VICTA

SERVICE BULLETIN NO. A.1.

SERVICE BULLETIN NO. 2

SUBJECT Exhaust pipe stay assembly - Mod. No.B.2.

FIG. 1 EXHAUST STAY ATTACHMENT.

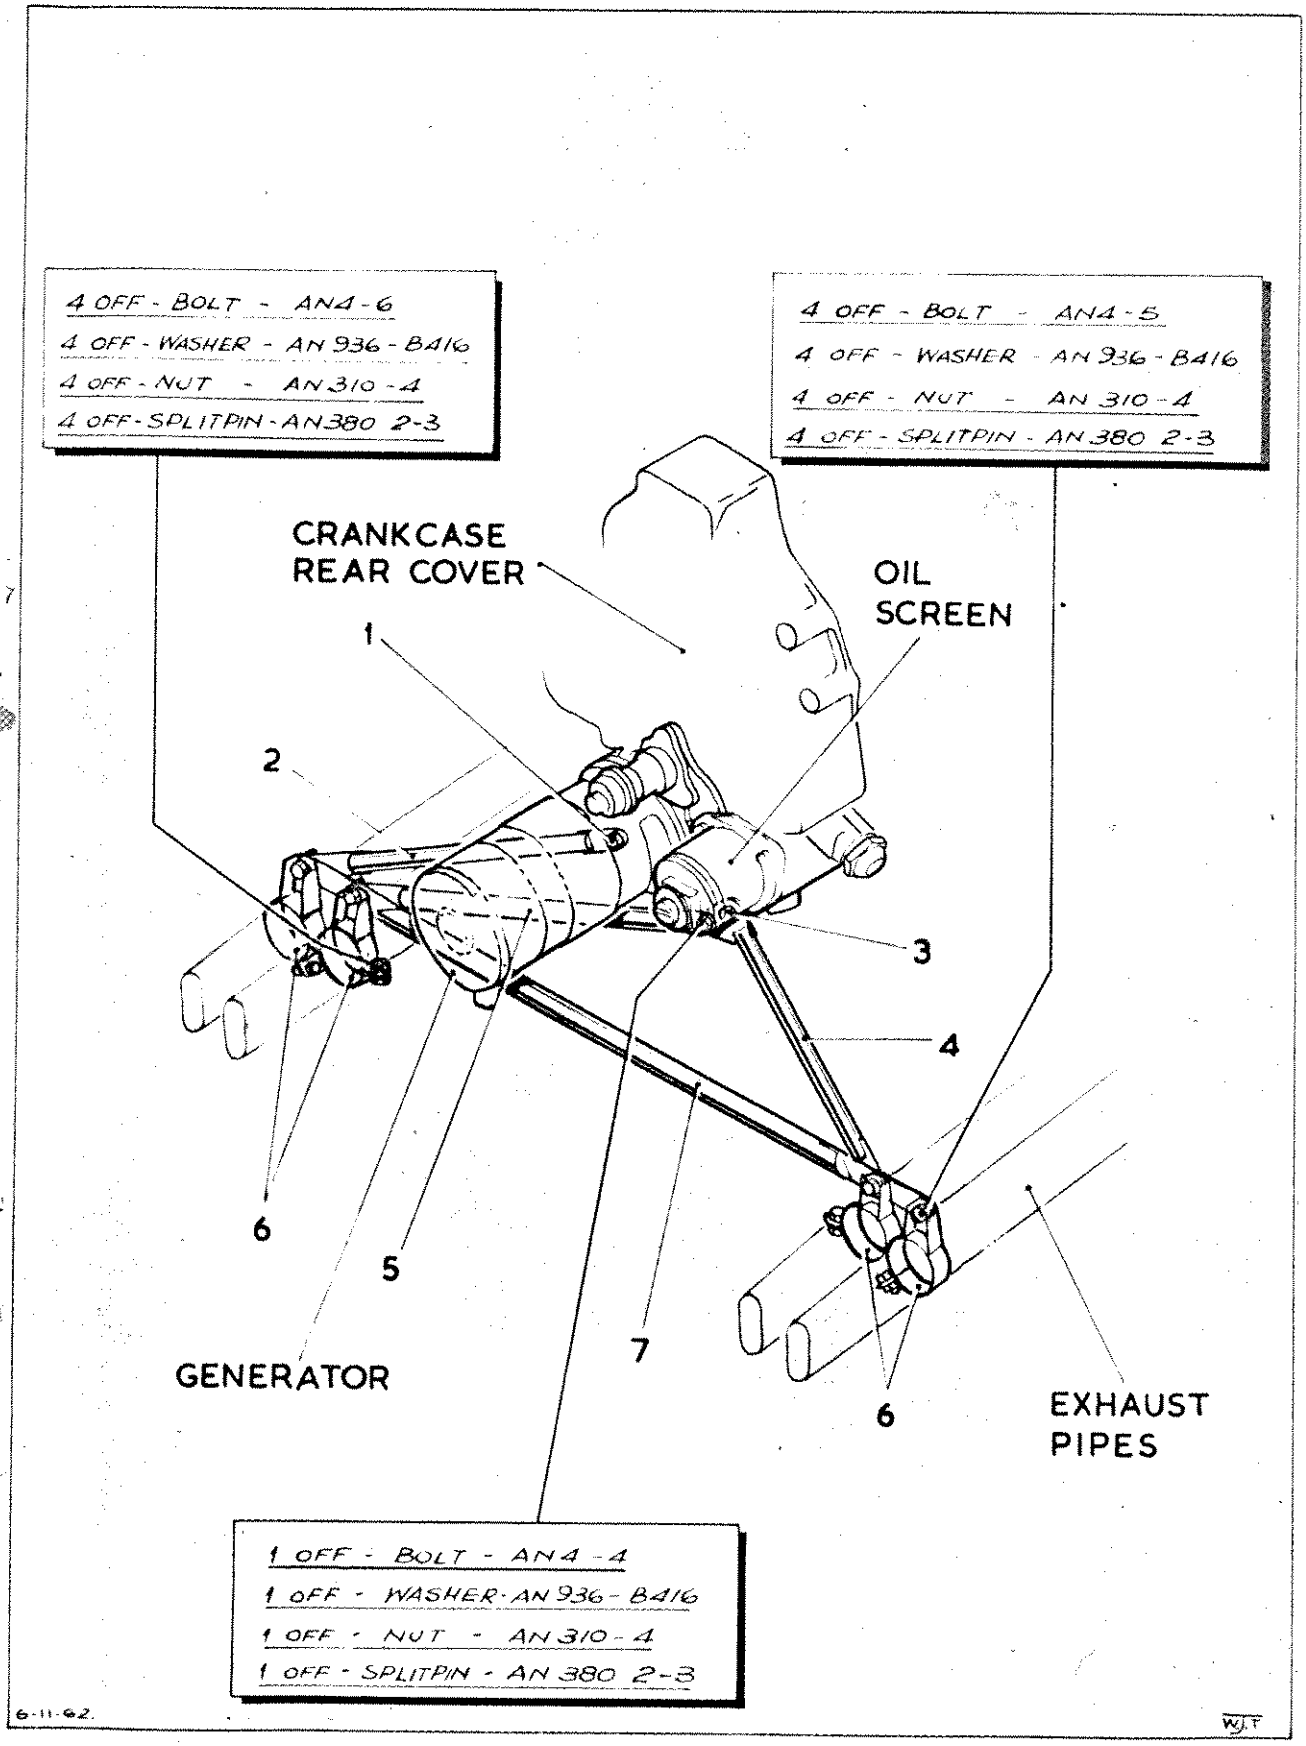
DETAILS Rectification of the exhaust flange cracking consists of installing a triangulated tubular structure picking up on two points at the rear of the engine and supporting the rear ends of the exhaust pipes. Refer to attached Fig. 1 in conjunction with details listed below when installing the stay structure.

(e) (Refer to Fig.1) Remove bottom left hand nut and washer (1) from generator attachment flange. Discard washer and fit L/H. outer stay (2).

(f) Remove bottom nut and washer (3) from oil screen attachment flange. Discard washer and fit R/H. outer stay (4).

(g) Attach inner stay (5) to lug on R/H. outer stay

(h) Fit exhaust pipe clamps (6) to rear of exhaust pipes.

(j) Attach bottom stay (7) to exhaust pipe clamps and inner and outer stays. DO NOT TIGHTEN BOLTS AT THIS STAGE

FIG. 1. NOSE-LEG SHEAR WEB ATTACHMENT

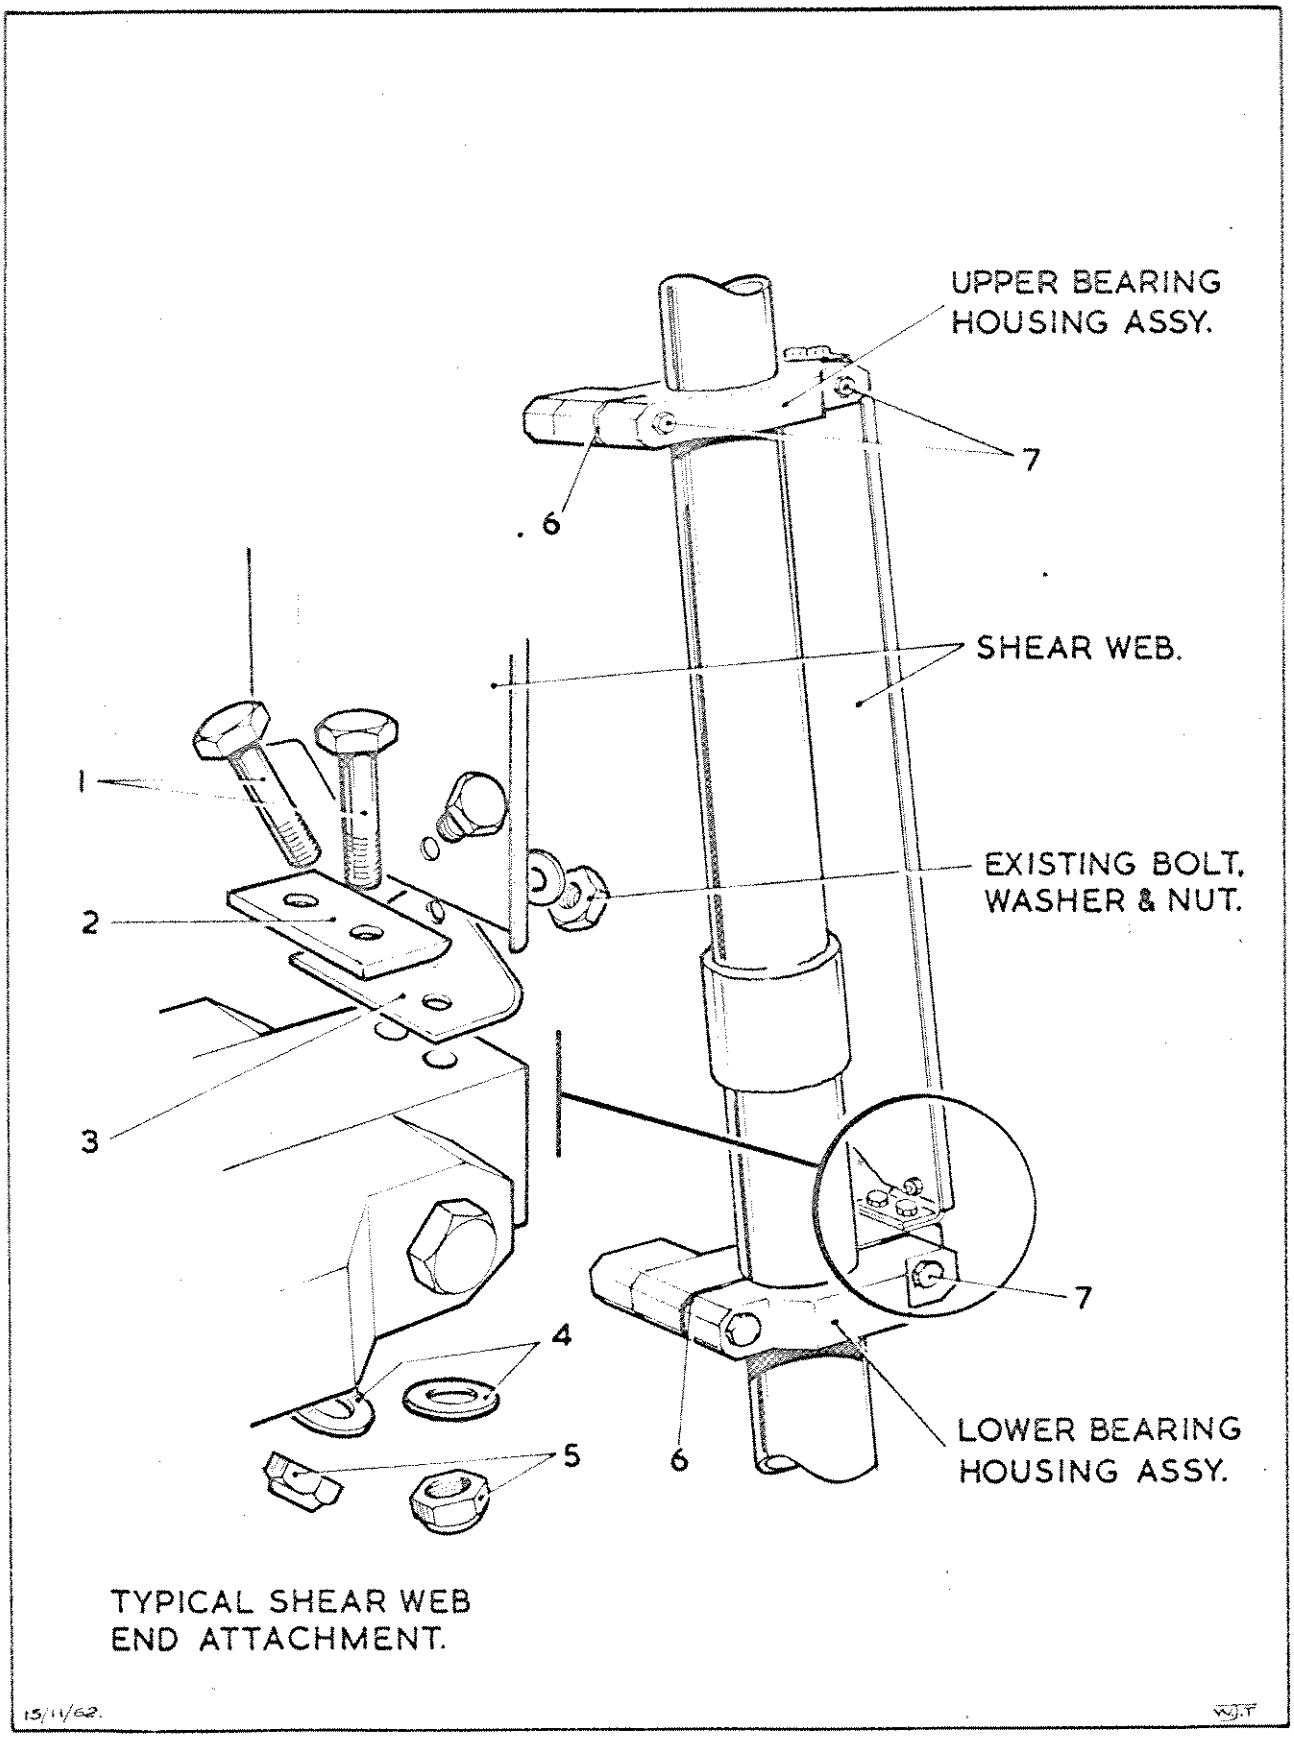
DETAILS Rectification of the failure of the attachment angles is achieved by fitting heavier gauge steel angles in place of aluminium alloy angles and 10 SWG aluminium alloy packers under the attachment bolts.
Refer to Fig. 1 attached in conjunction with details listed below

(a) Check that upper and lower bearing housing attachment bolts (7) have not worked loose.

(b) Check that the packer (6) is in position between the faces of the bearing housing segments and that tightening of the attachment bolts (7) does not tighten bearing onto nose leg.

(c) Remove nuts, bolts and washers securing angles to upper and lower bearing housings and discard.

(d) Remove angles from shear web and discard, but retain attaching bolts, washers and nuts.

(e) Replace old aluminum angles with steel angles (3) and aluminium packer (2) which is inserted beneath the heads of new bolts (1) which secure the angles to the bearing housing in conjunction with washers (4) and nuts (5).

(f) Before securing shear web to angles in it may be necessary to trim the end of the web to clear the aluminium packer.
